Your Ref
EG/39/18/HH
Our Ref
PLAN-023659
Date
02/08/2018

Proposal: Ground floor rear extension.
Site: 2 The Cedars, Barnham PO22 0EZ.
EG/39/18/HH

Southern Water MapGuide Browser

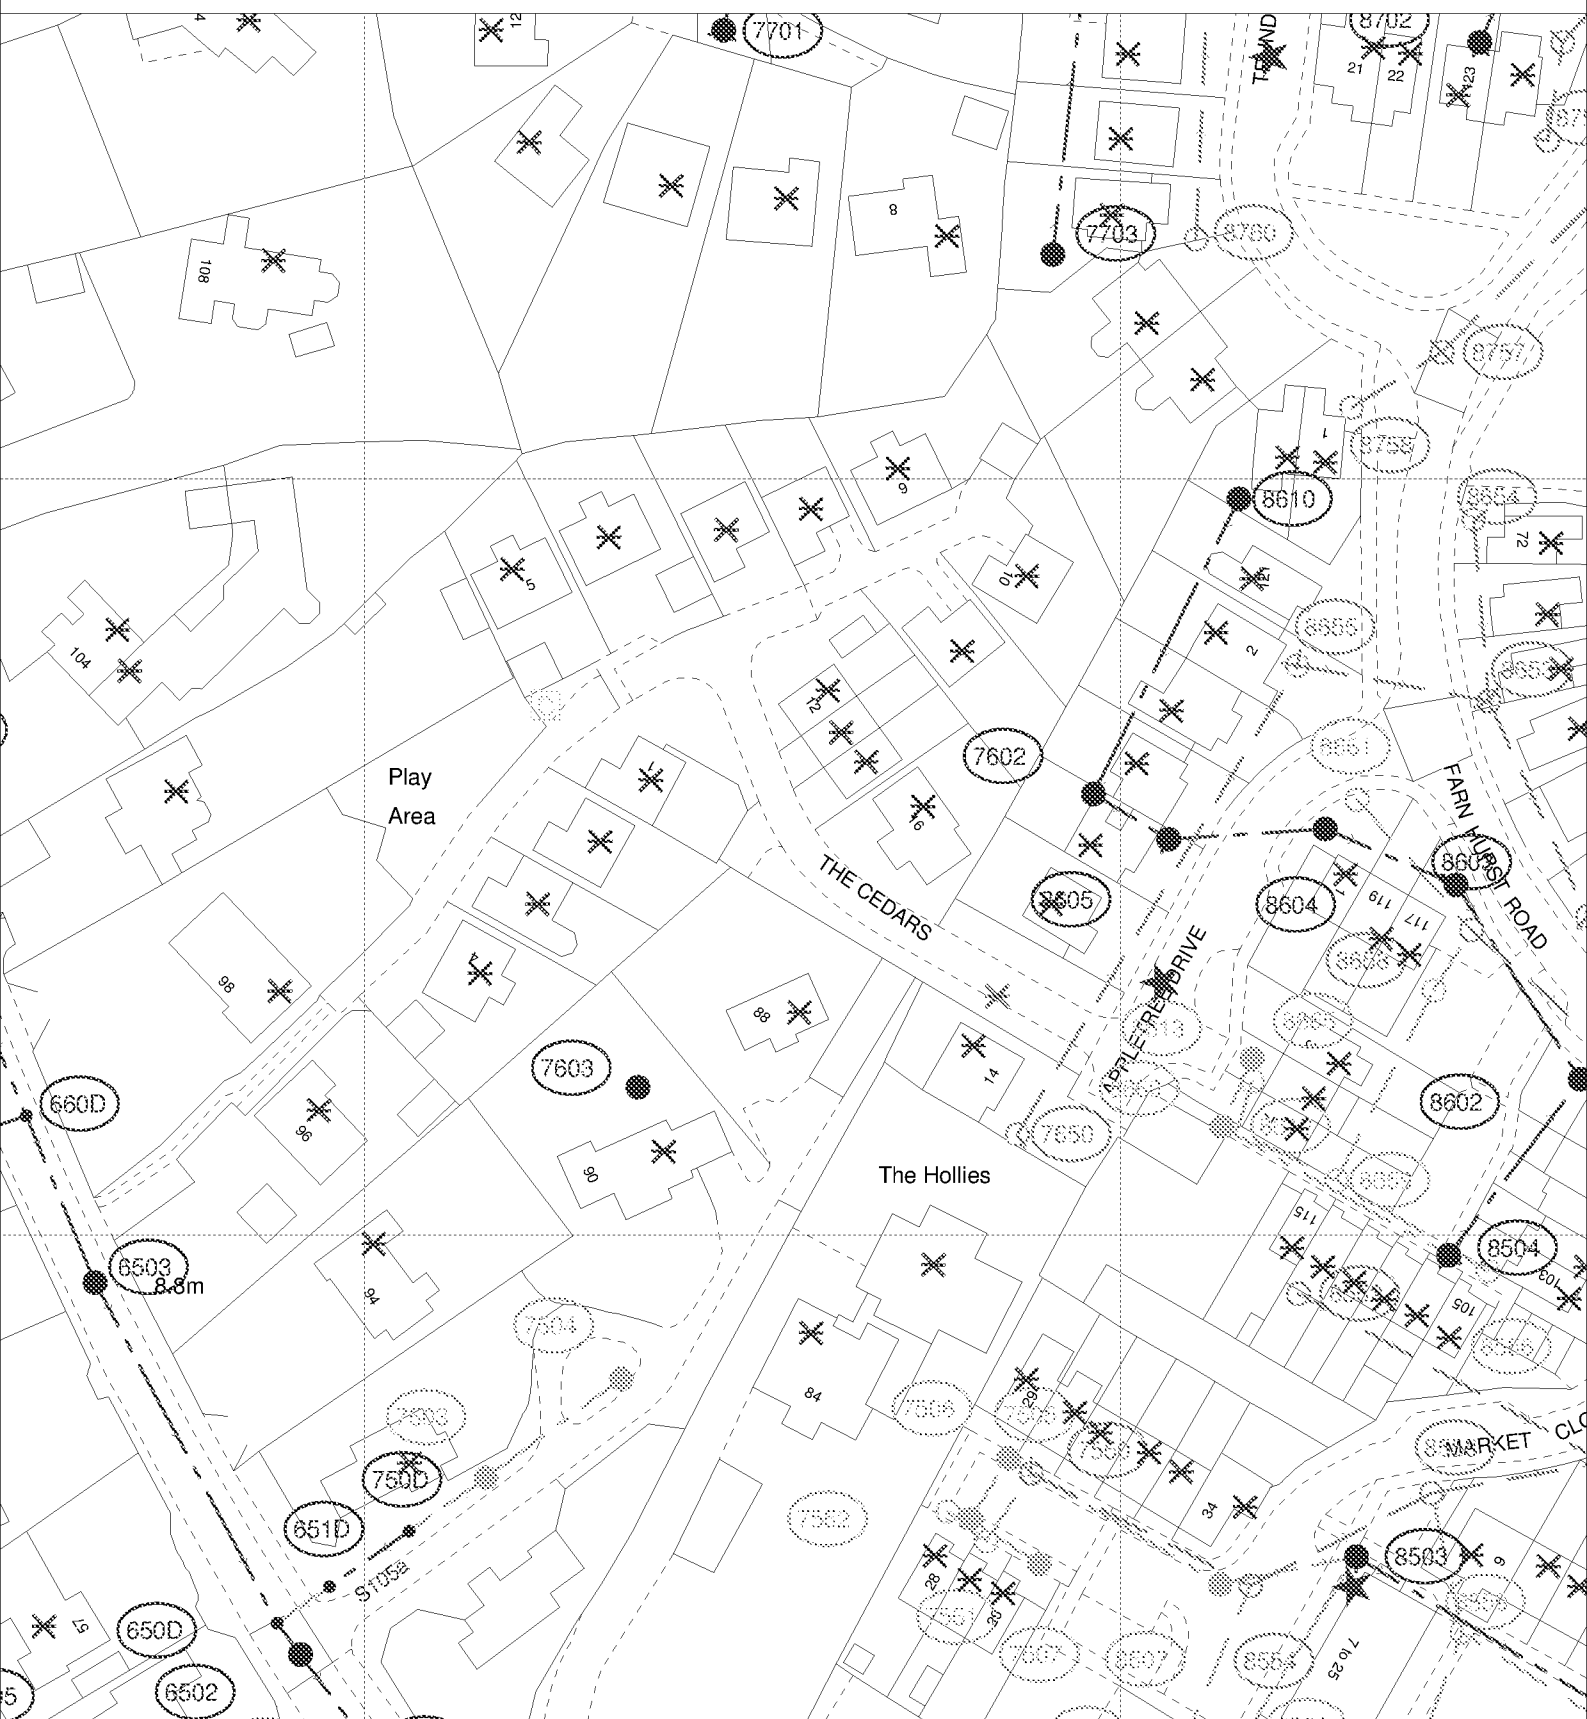
Due to changes in legislation that came in to force on 1st October 2011 regarding the future ownership of sewers it is possible that a sewer now deemed to be public could be crossing the above property. Therefore, should any sewer be found during construction works, an investigation of the sewer will be required to ascertain its condition, the number of properties served, and potential means of access before any further works commence on site.

Due to surface water inundation issues in the Lidsey Catchment "The applicant is advised to adopt, where appropriate, the measures in the table "Practical measures to reduce the potential impacts of development".

Developer should look to protect the public sewerage system from inundation and infiltration, which contribute to flooding in unfavourable conditions.
